ADDENDUM NO. 02
LEGRANDE ELEMENTARY SCHOOL ADDITION AND RENOVATION
SCB PROJECT NO. 2210

DATE: August 23, 2023

The purpose of this Addendum is to clarify further the requirements of the plans and specifications. The bidders are governed by the information in this Addendum as if included in the plans and specifications. This Addendum does hereby become a part of the Contract Documents. Each bidder shall acknowledge receipt of this Addendum in the space provided in the Bid Form.

1 FIRST FLOOR - LIGHTING
SCALE: 1/8" = 1'-0"

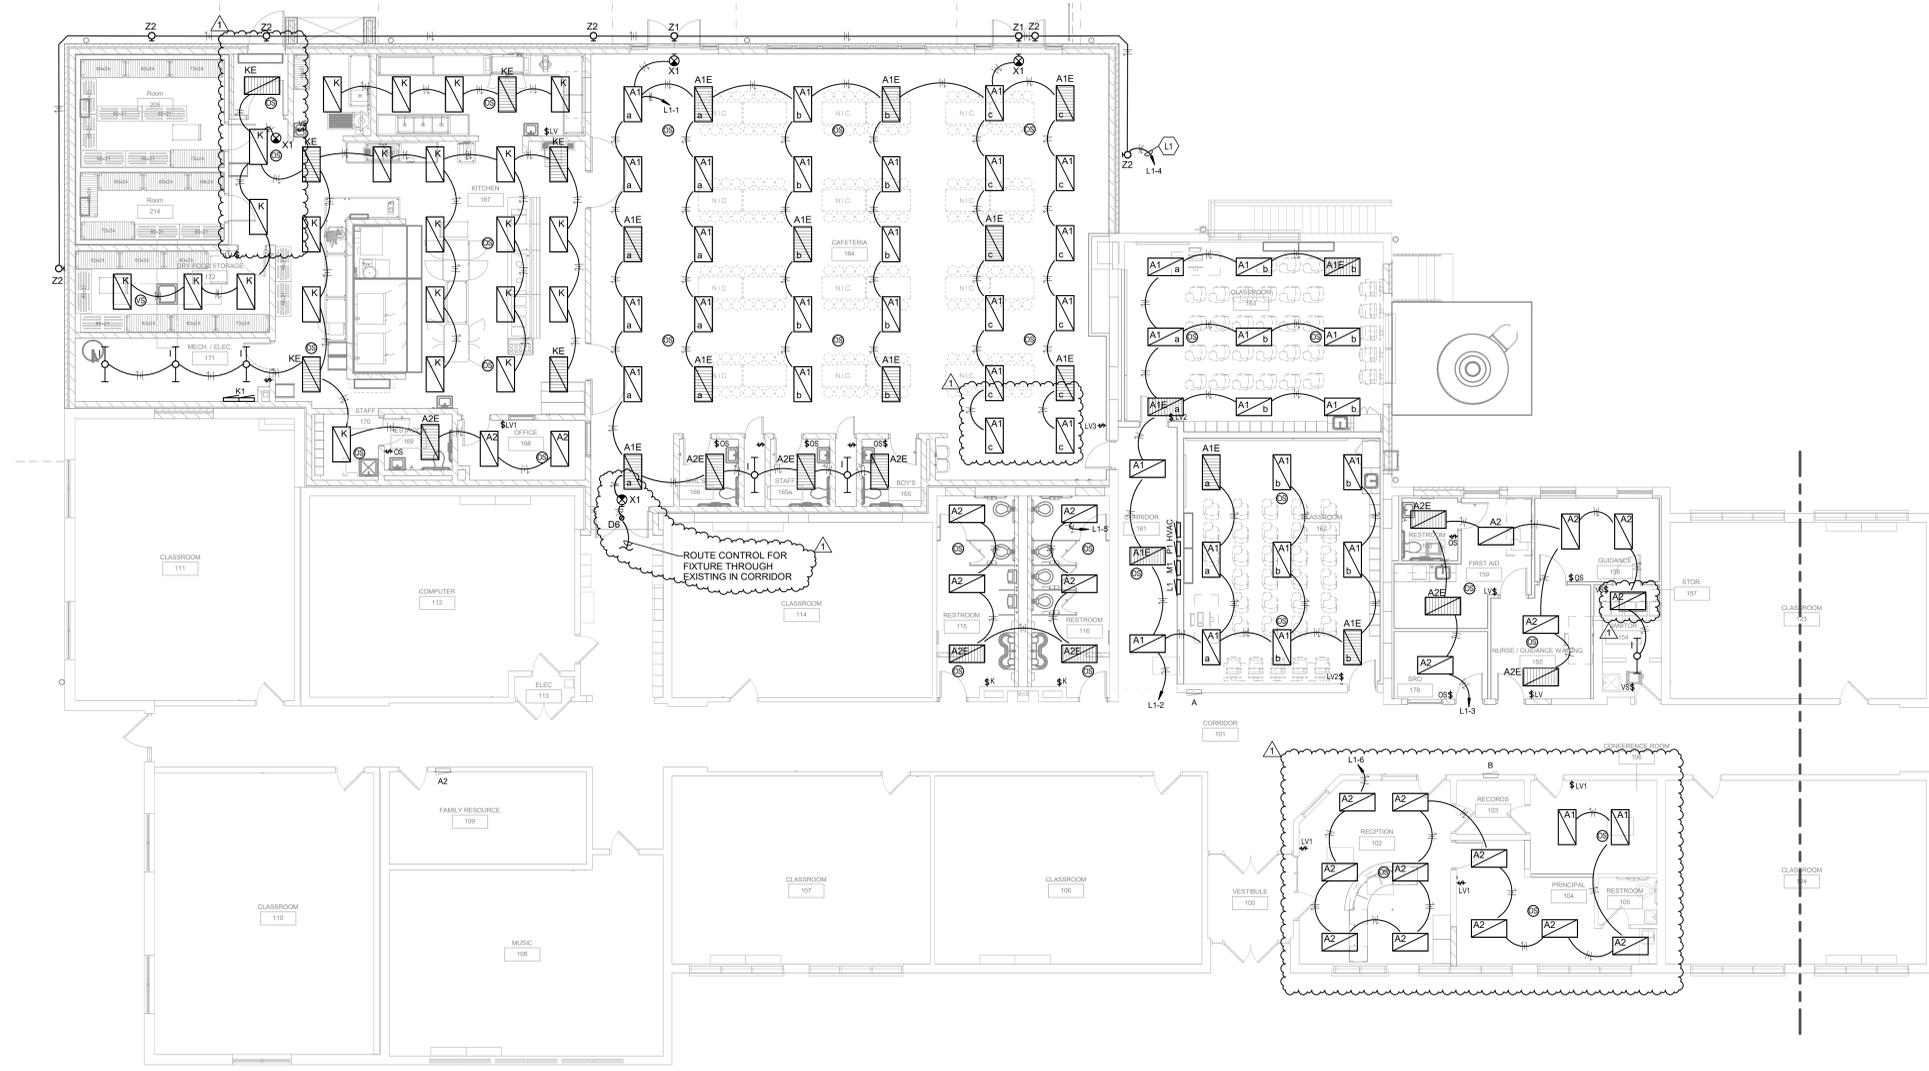
- a. Added new sheet to show demolition of fire alarm system and all fire alarm devices.
7. Sheet E1.1 – First Floor Plan - Lighting
 - a. Added downlight fixture D6 in soffit over door outside of Cafeteria 164.

- b. Added new lighting and lighting controls in Reception 102, Principal 104 and Conference Room 106.
 - c. Added two fixture A1 in Cafeteria 164.
8. Sheet E2.1 – First Floor Plan – Power

E2.2

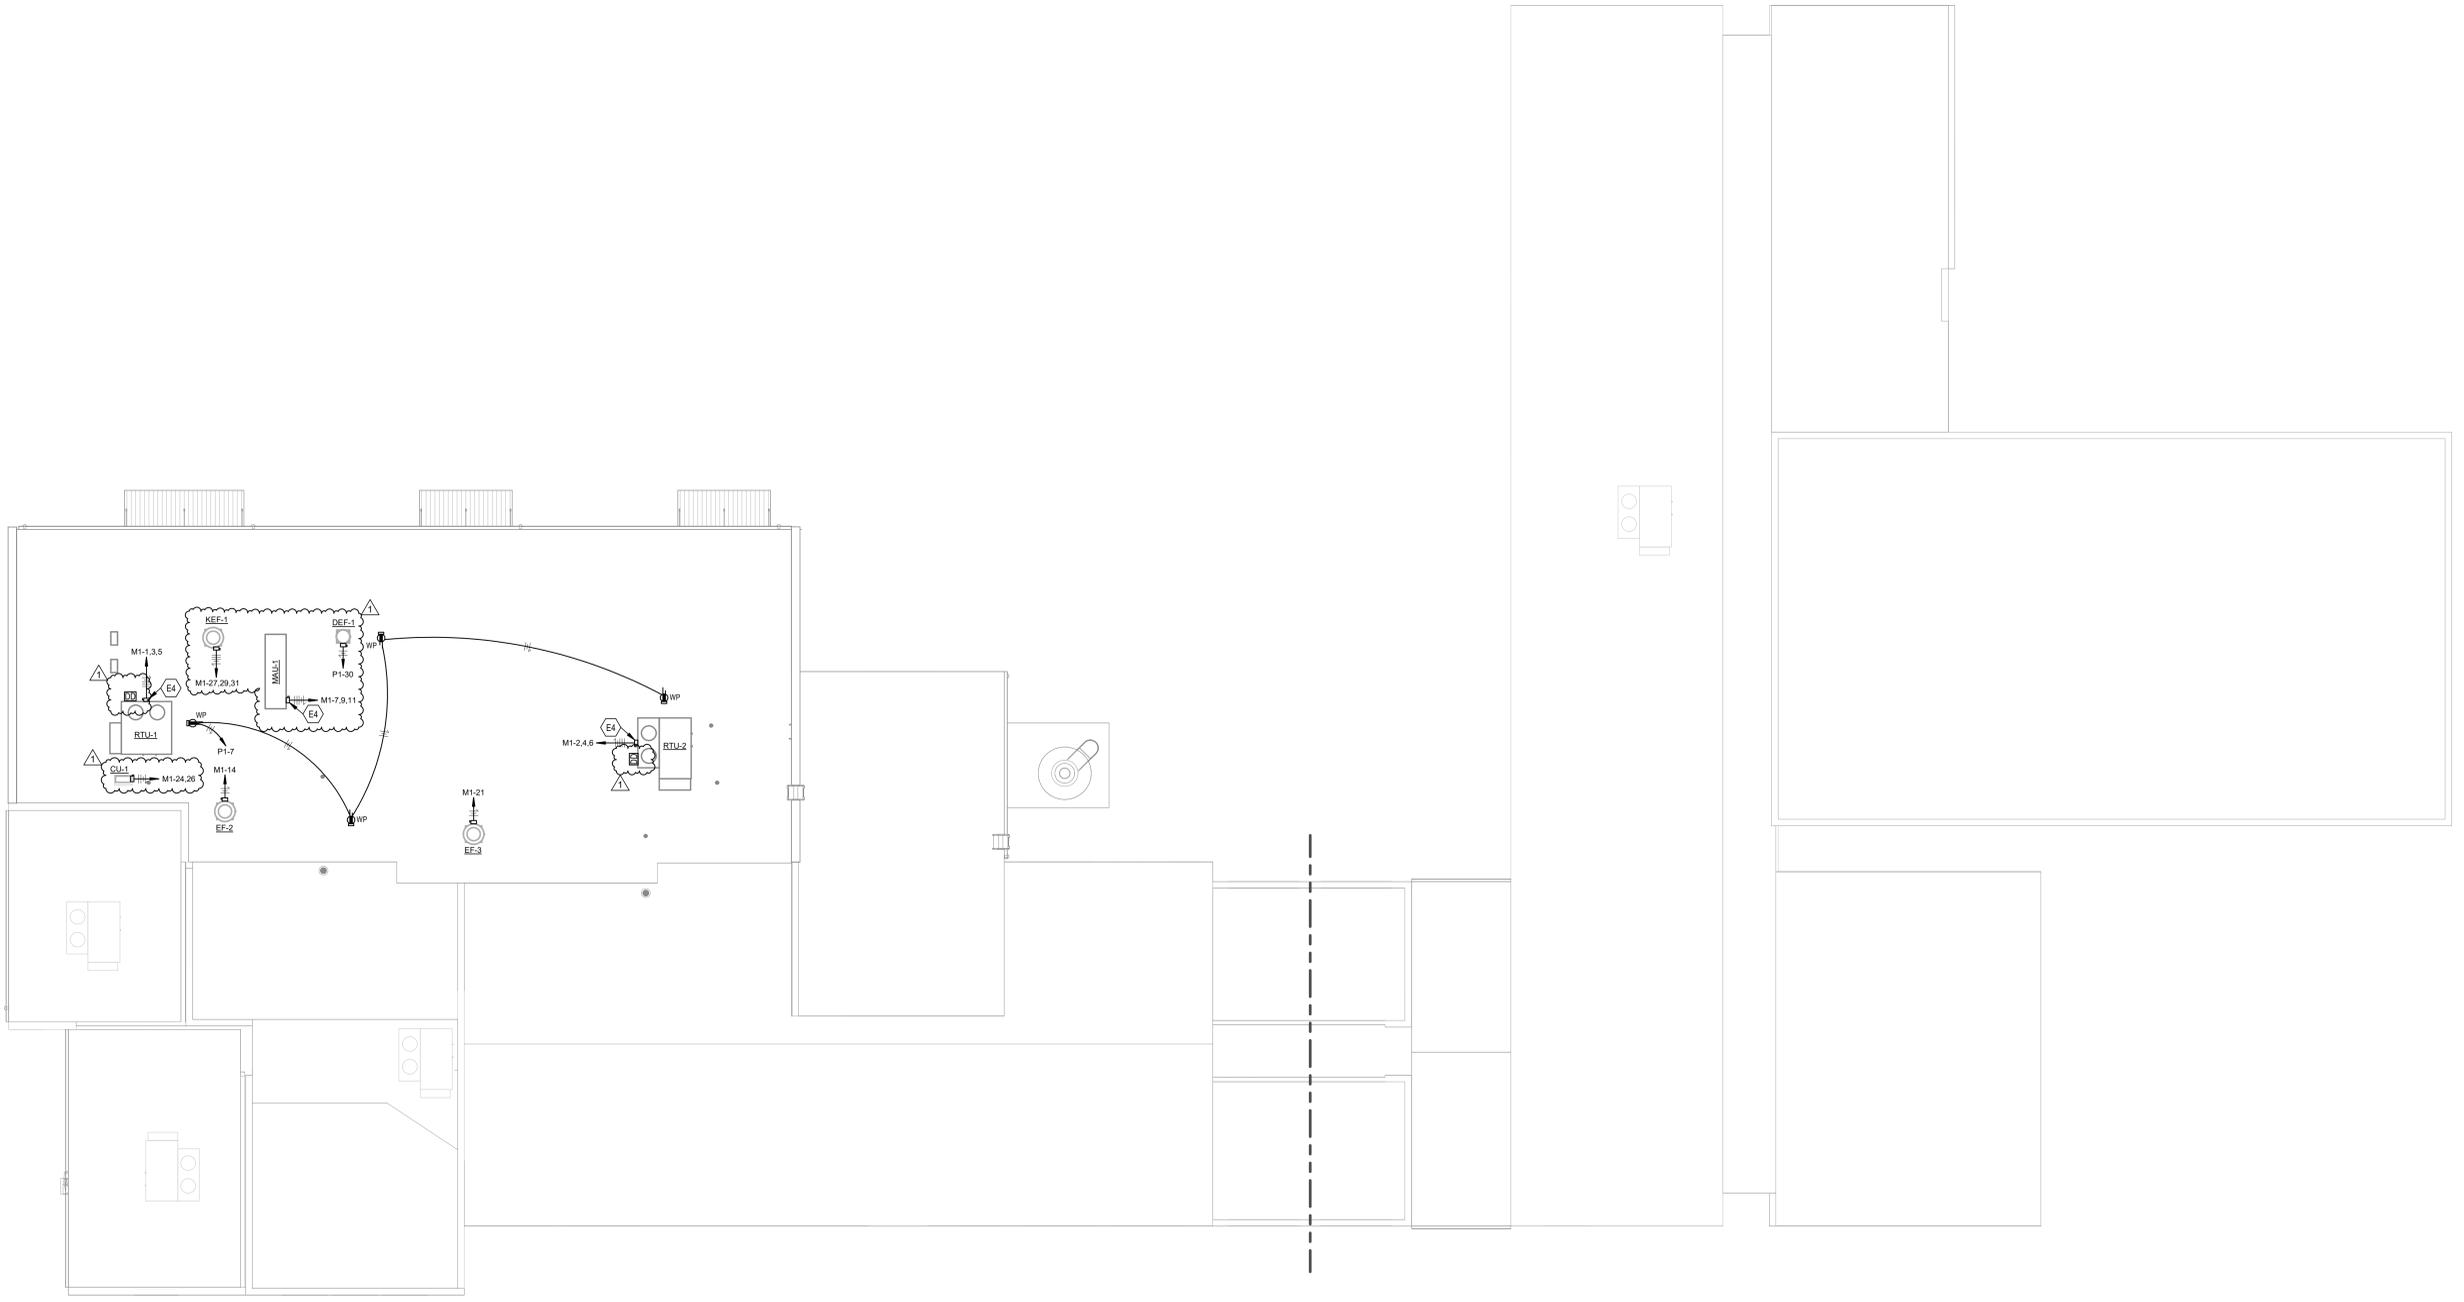
- a. Revised exhaust fan EF-1 and EF-2.
9. Sheet E2.2 – Roof Plan – Electrical
 - a. Revised mechanical equipment CU-1, KEF-1, MAU-1 and DEF-1.
 - b. Added duct detectors to the rooftop units.

1 FIRST FLOOR PLAN - SYSTEMS
SCALE: 1/8" = 1'-0"

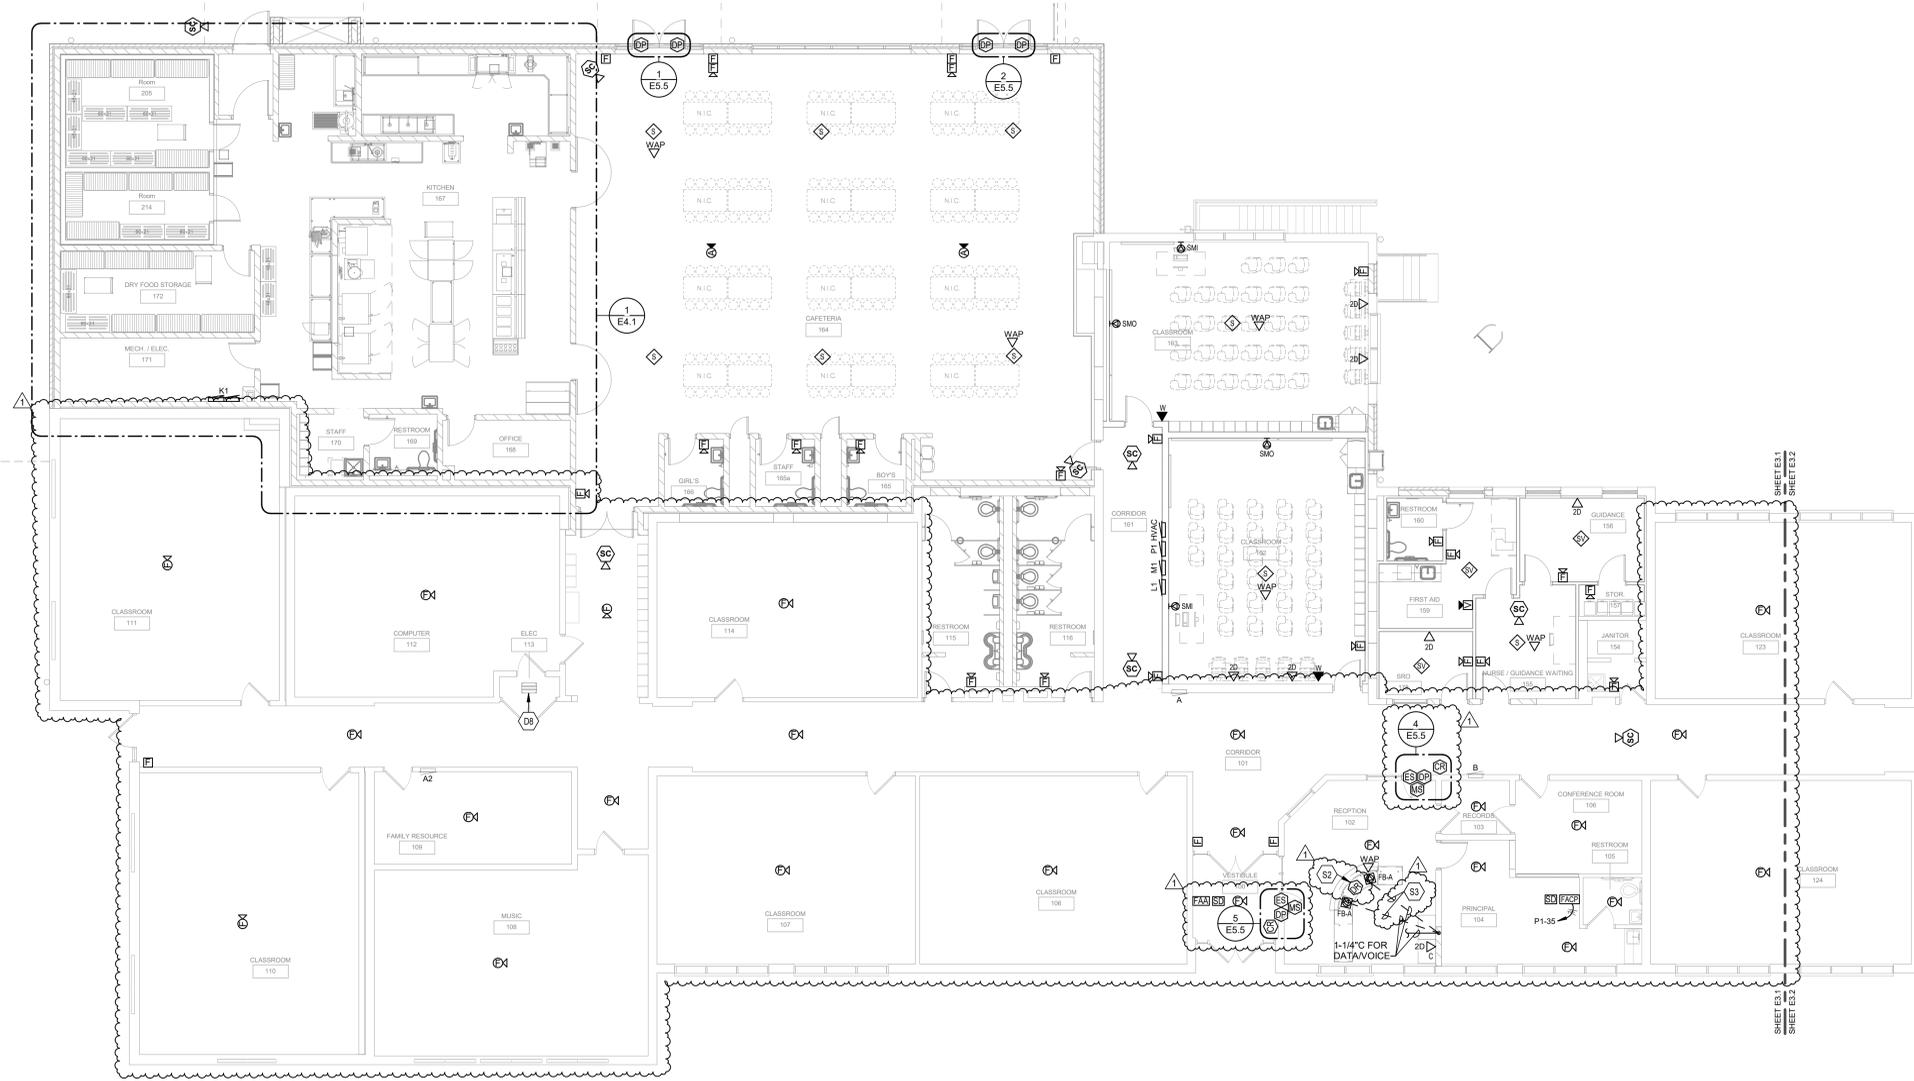
10. Sheet E3.1 – First Floor Plan – Systems
 - a. Added access controls to doors at Reception 102.
 - b. Added new fire alarm system and fire alarm devices for all existing and new areas.

- c. Added keynotes S2 and S3.
 - d. Added Basement view.
11. Sheet E3.2 – First Floor Plan – Systems
 - a. Added new sheet to show new fire alarm system and fire alarm devices.

4 KITCHEN DISHWASHER EQUIPMENT CONTROL SCHEMATIC
NO SCALE

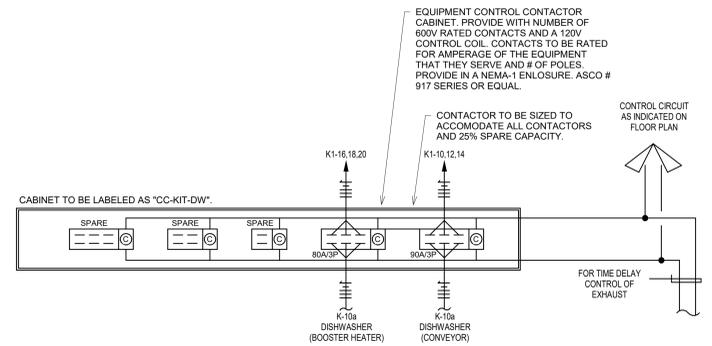
12. Sheet E4.1 – Enlarged Kitchen Plan – Electrical
 - a. Revised Enlarged Kitchen Plan.
 - b. Revised Kitchen Equipment Connection Schedule.
 - c. Revised Detail 4, Kitchen Dishwasher Equipment Control Schematic.

7 KITCHEN HOOD (KH-2) CONTROL SCHEMATIC (FOR TYPE 1 HOOD)
NO SCALE

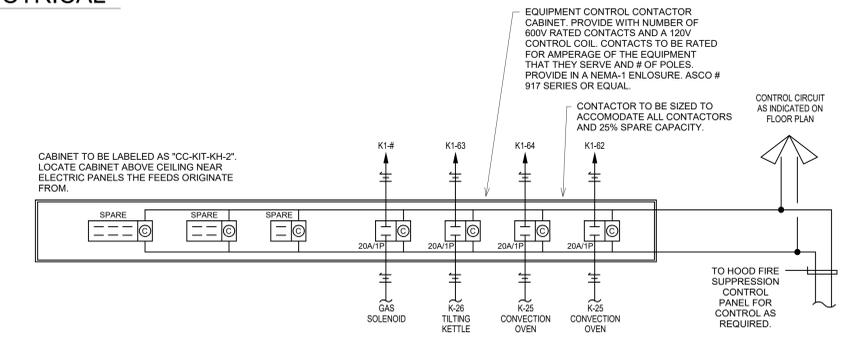
- d. Revised Detail 5, Kitchen Hood (KH-1) Control Schematic (For Type 1 Hood).
 - e. Revised Detail 7, Kitchen Hood (KH-2) Control Schematic (For Type 1 Hood).

E7.2

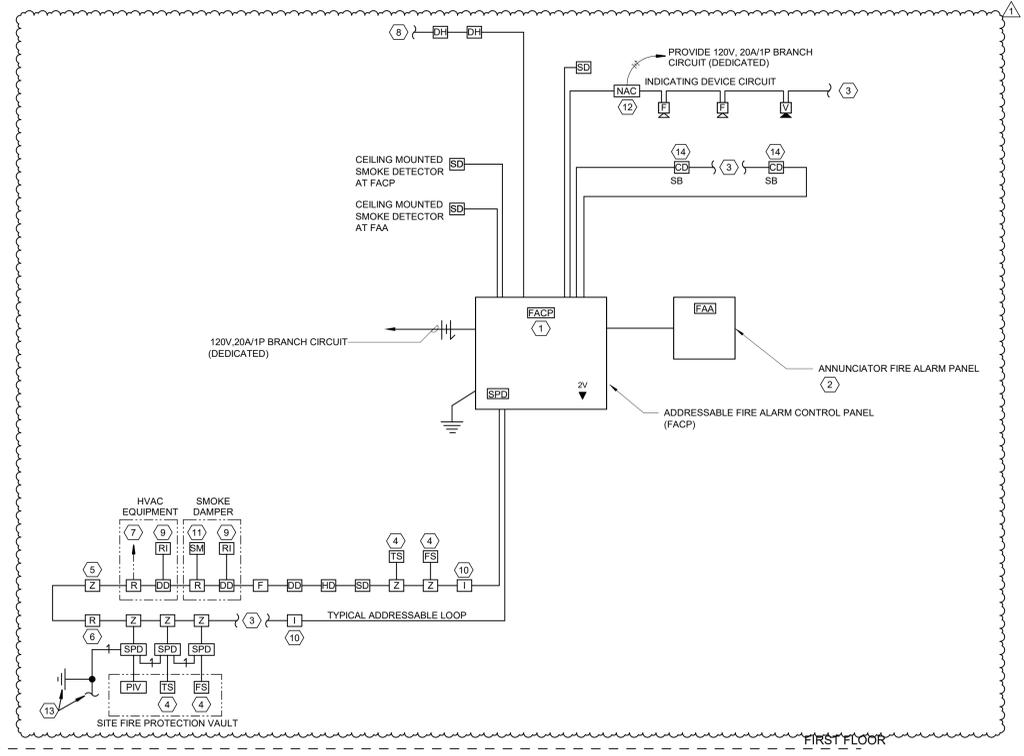
17. Sheet E7.2 – Fire Alarm Riser Diagram
 - a. Revised Fire Alarm System Riser Diagram to show entire new system.

1 MECHANICAL ZONING PLAN
SCALE: 1/8" = 1'-0"

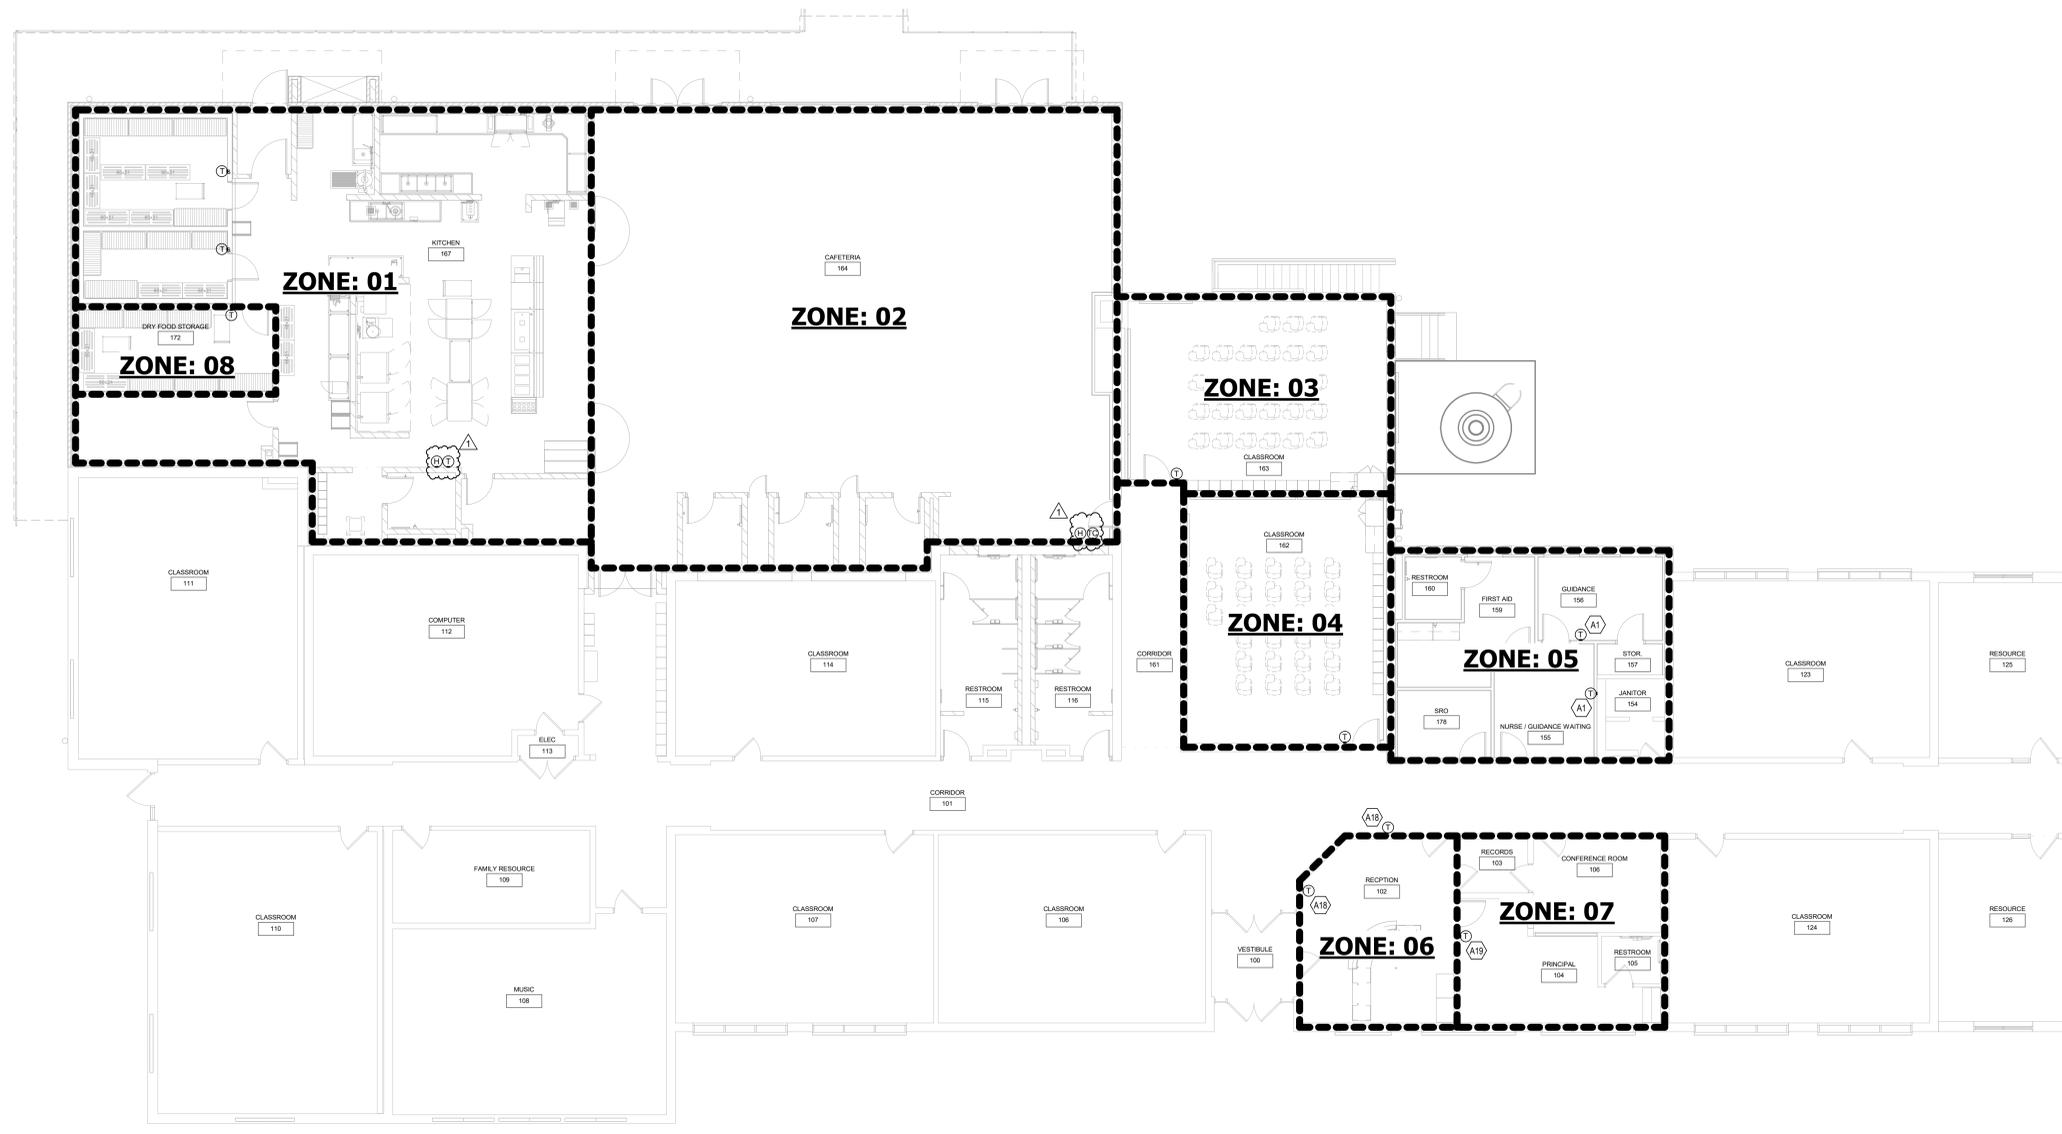
1. Sheet M1.1 – Mechanical Zoning Plan

- a. Added Humidity sensor in Kitchen 167 & Cafeteria 164.
2. Sheet M2.1 – First Floor Plan – Mechanical Demolition
 - a. Added demolition scope for the admin area.
